ASSESSMENT REPORT – SECTION 96 MODIFICATION

DA No:	DA/496/2016/B
Assessment Officer:	Bertha Gunawan
Property:	1 Post Office Street (also known as 794 Pennant Hills Road) CARLINGFORD NSW 2118 (Lot 1 DP 135802)
Proposal:	Section 96(2) modification to an approved construction of a nine storey residential flat building containing 53 units with ground floor retail. The proposed modifications include changes to the balconies on L4-6 which increases the gross floor area, conversion of 2 units into dual key units, minor external and internal changes and corrections to errors in plans.
Date of receipt:	22 December 2016
Applicant:	LATERAL ESTATE PTY LTD
Owner:	Best Village Pty Ltd
Submissions received:	Two
Property owned by a Council employee or Councillor:	The site is not known to be owned by a Council employee or Councillor
Political donations/gifts disclosed:	None disclosed on the application form
Issues:	None
Recommendation:	Approval

Approved elevation from Pennant Hills Road

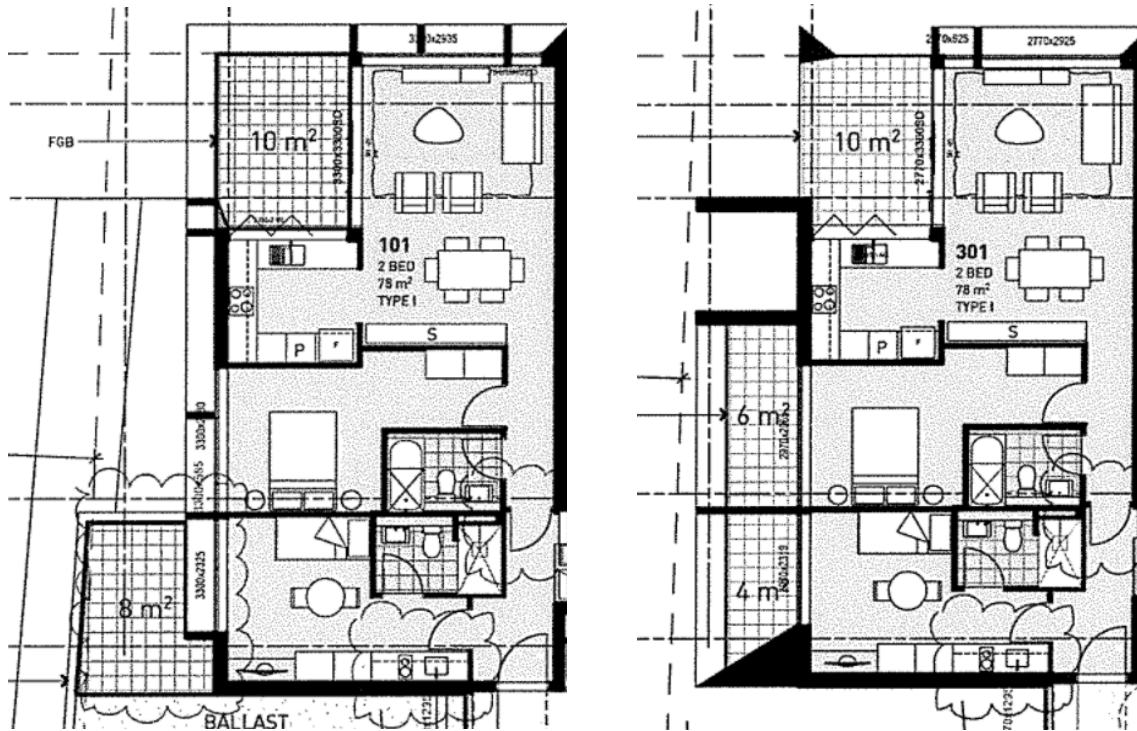
3. Conversion of balconies into loggias/winter gardens on Levels 4 – 6 for Units: 406, 407, 408, 504, 505, 506, 605 and 606 (which are facing Pennant Hills Road), and
Additional GFA = 76m².

As noted in comparison between the approved and proposed elevation plans, the loggias/winter gardens will maintain a similar appearance to the street. In this instance, there is no perceived bulk and scale impacts and the proposed FSR variation is found to be satisfactory.
